Addendum #1

REQUEST FOR PROPOSAL – RETAIL & DUTY FREE CONCESSION OPPORTUNITY

QUESTIONS & REQUESTS FOR INFORMATION – MARCH 25, 2022

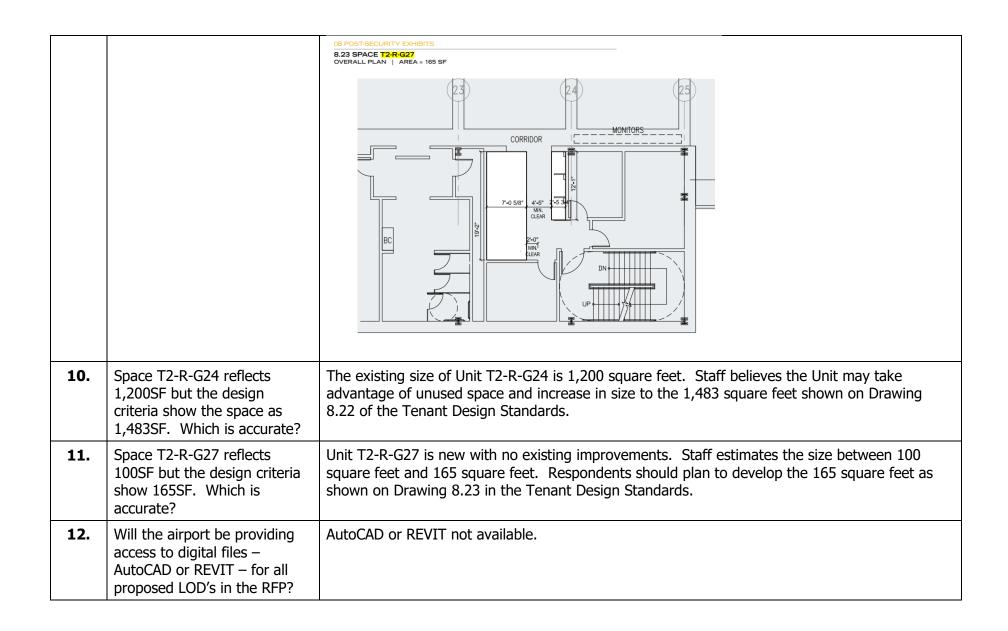
8.	Is Retail Node T2-R-G27 a long, narrow "closet"? What will draw travelers to that area? Will it be visible to a seating area/passersby?	Retail Node T2-R-G27 is currently a vacant alcove area with existing electrical and plumbing. The alcove entry should be widened to improve visibility. Please visit us online at: https://www.portofoakland.com/wp-content/uploads/2022-02-01-OAK-Tenant-Design-Standards.pdf . A copy of the Tenant Design Standards – 2022 Retail & Duty Free Concession Opportunity at OAK (posted 02/01/2022) is available for download. The outline dimensions for each Unit is provided in this document. Below, please find the overall plan for this Retail Node T2-R-G27.

9.	Space T2-R-G27: Plans from Tenant Design Guidelines include small area on the east side as part of the space. Should this space be included as part of the RFP design?	See response C.8. above. Below, please see as well overall plan for this ASR Node. The small area on the east side of the space may also be developed as part of the ASR Node design as incorporated in a Proposal. This drawing is to provide the Respondent with an idea on how this area may be developed. Respondent may propose an alternate option so long as a common path of travel (shown below) remains available to the stairwell and other rooms.
